From: Brad Feldhaus <bradfild55@gmail.com>
Sent: Thursday, May 27, 2021 10:17 AM
To: Williams, Jeffrey
Cc: Bricker, Robert; jerry@gregharmanhi.com; Tere Feldhaus
Subject: Waiver Request to Reduce Set Back Distance for Hot Tub Installation
Attachments: ATP Scan In Progress

OWNER: Bradley Feldhaus PHONE #: _____
ADDRESS: 697 Weller Drive CONTRACTOR: _____
SUBDIVISION: Patapsco Overlook, Sec 3 LOT: 33 WELL TAG #: _____
COUNTY #: _____
PROPOSAL: Install 7'x7' concrete pad for hot tub
approx. 1' from existing SDA

Feldhaus Residence
697 Weller Dr
Mt Airy MD 21771

Feldhaus Residence
Deck & Hot Tub

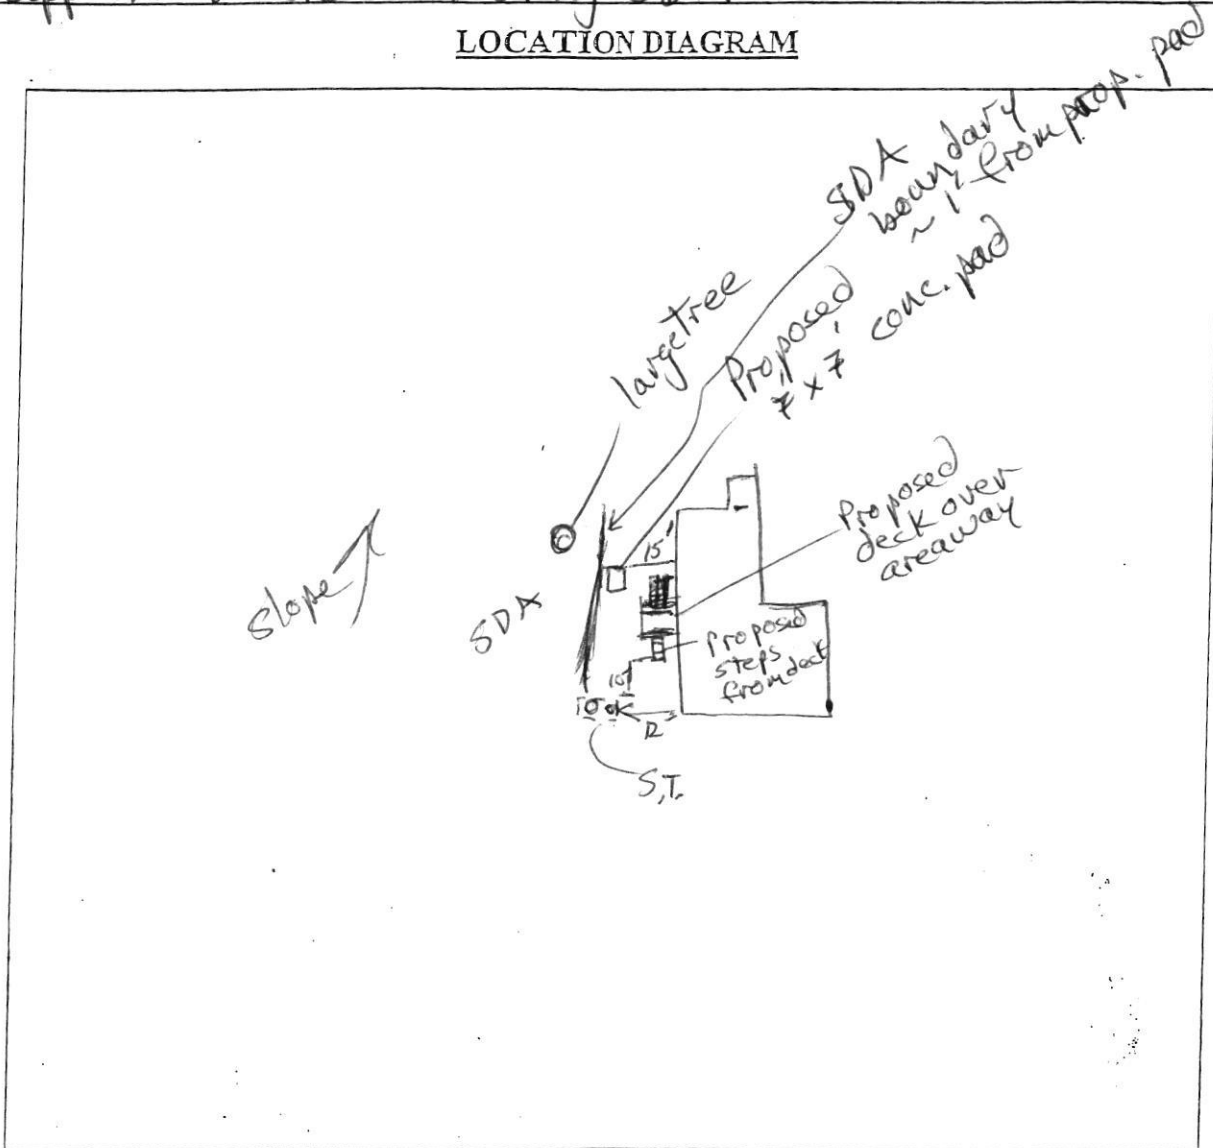
We met with Mr. Bricker this morning on our lot to review the proposed location for a hot tub we want to install next to our house at 697 Weller Drive. With the proposed location, the outer edge of the tub would be 22 feet from the house, and the location would be inside of the 10 foot setback from the septic field reserve area. Mr Bricker suggested that a waiver could be an option so that we can maintain the hot tub location at (or close to) the current proposed location.

I was able to locate on the county Website the attached drawing submitted and approved for the actual septic field from the construction of the house in 1988.

- Since any expansion of the field, should it be necessary, would be downhill from the existing field, it would likely not be a problem with the proposed hot tub location.
- The well and potable water line for the house are in the front, and do not come close to the septic area.
- The hot tub will not have water lines. It will be hose filled so there are no water lines to be added for the proposed installation site.

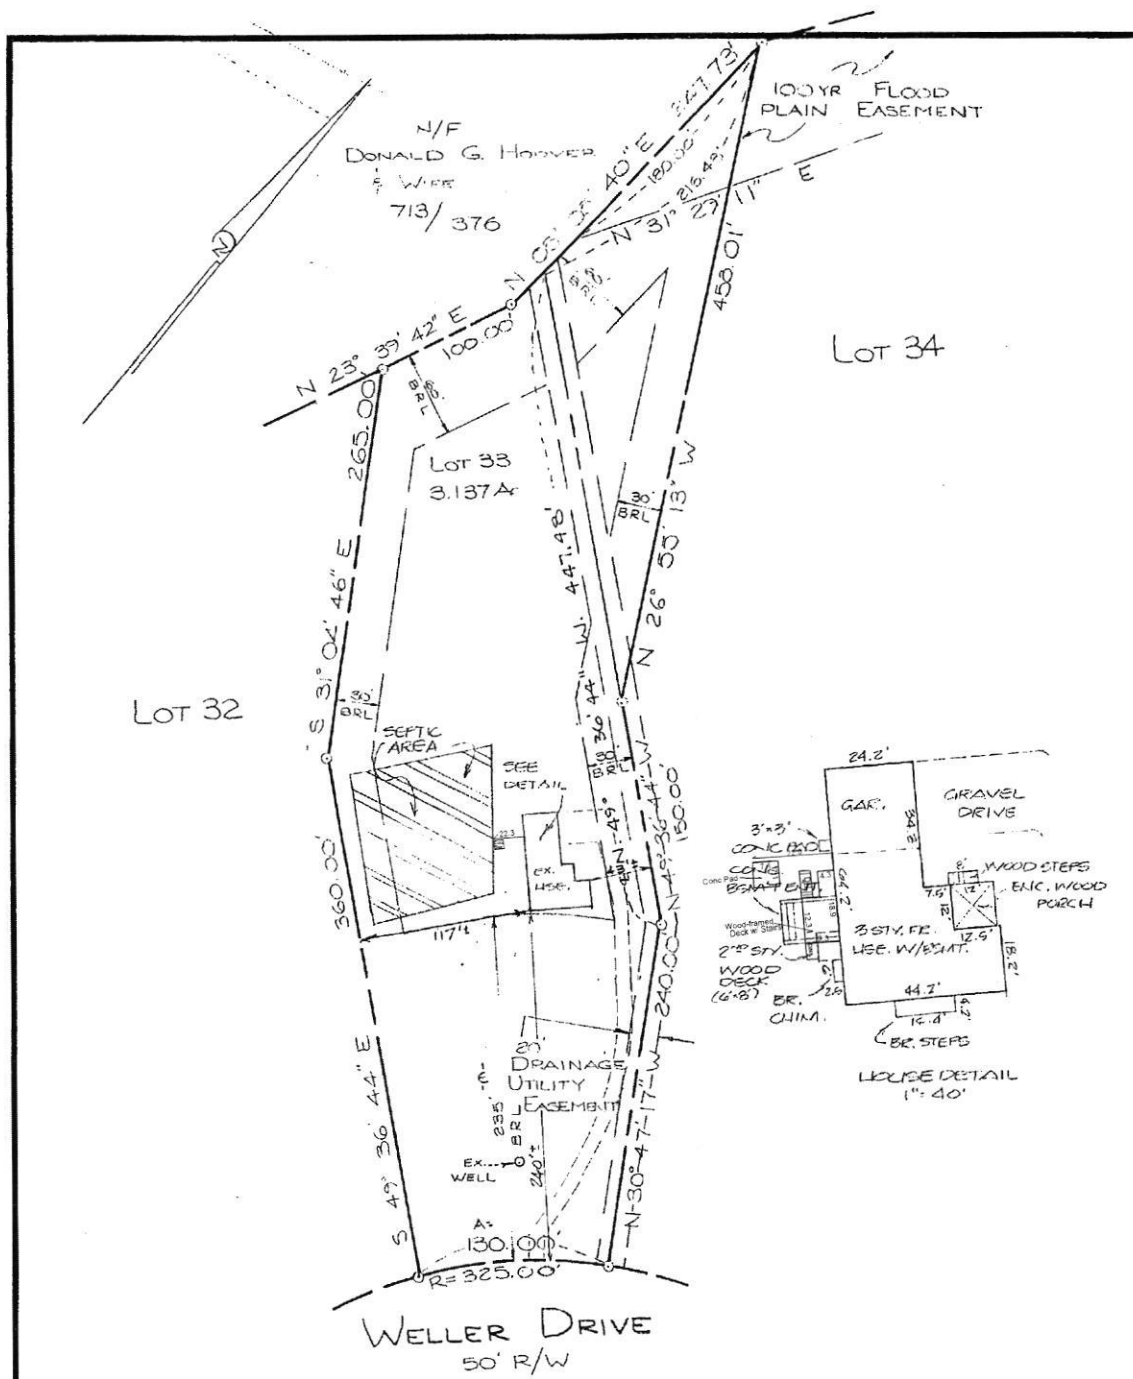
COMMENTS: Septic Tank is approx. 30 feet from
proposed concrete pad (hot tub)
Hot tub to be filled from hose bib or
by delivered water
DATE: 5/27/21 INSPECTOR: R. Bricker
